NOTICE OF THE MEETING OF THE PLAN COMMISSION

ITEM #1 PUBLIC HEARING - SUNSET ESTATES TOWNHOME DEVELOPMENT, 6864 & 6900 179TH STREET – ARCHITECTURE/SITE PLAN APPROVAL, ANNEXATION/FINAL PLAT APPROVAL, REZONING, VARIATION

PLAN COMMISSION STAFF REPORT

Paula J. Wallrich, AICP Planning Manager Sunset Estates Townhome Development Revisions resulting from workshop are noted in red. 17870-17881 179th Street

Roadway Framework Plan

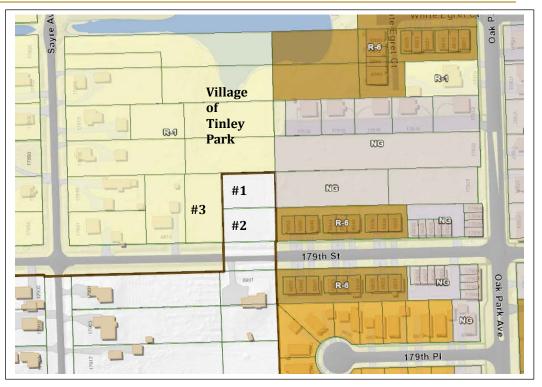
After discussion amongst staff at the monthly <u>Development Review Team</u> (interdepartmental meetings comprising representatives from Engineering, Public Works, Fire, Building, Police and Planning), and for the reasons stated above, it was decided that Sunset Estates (yellow star) did not have to provide a connection to the north. This decision was made with the understanding

that staff has also been working with the property owner to the east (blue star) and will be proposing a development in the near future.

Open Item #1: Discuss the Legacy Plan's proposed road alignments and relevancy to the proposed Site Plan. There was no discussion on the relevancy to the Legacy Plan ZONING & NEARBY LAND USES

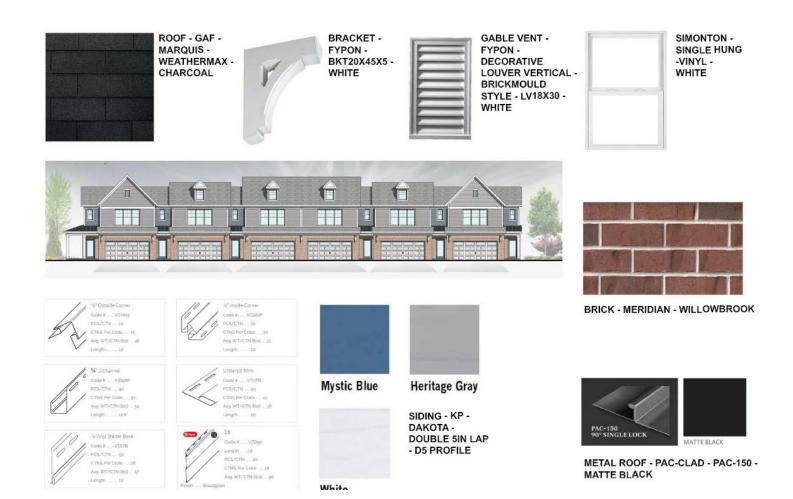
Landscaped bufferyards are required along the west, north and east property lines. Due to the existing vegetation on the north and the fact that the area will remain undeveloped, Staff recommended shifting some of the required planting from the north property line to supplement planting on the east and west property lines since they function as rear yards and are adjacent to existing side yards of developed property. With this transfer the proposed landscape plan exceeds ordinance requirements on the east and west sides of the property, however the north bufferyard no longer meets bufferyard requirements. Additionally, per Section 158.13 of the Landscape Ordinance, "Fences, walls, berms and/or hedges may be required to supplement required plant materials if the Department of Community Development determines that additional screening is necessary to shield a proposed land use from adjacent uses." A small berm with landscaping wraps the northwest and northeast corners of the development and a six foot solid vinyl PVC will be erected along the west and east property lines (see red dashed lines above). A small section of the same six foot solid vinyl fence will also be erected adjacent to each patio to screen it from the neighboring unit.

The fence is designed to be attractive on both sides. (see image at right) Staff felt it was unnecessary to install fencing along the north property line where there is existing vegetation. Some large trees have been preserved along the west property line. Street trees have been provided; foundation plantings have also been provided where space allows, with a concentration along the south side of both buildings due to the visibility from 179th Street

Open Item #3: Discuss whether the landscape plan meets the intent of the ordinance with the transfer of some of the landscape material from the north property line to the east and west bufferyards. There was no concern regarding the transfer of the bufferyards planting requirements from the rear yard to the side yards.
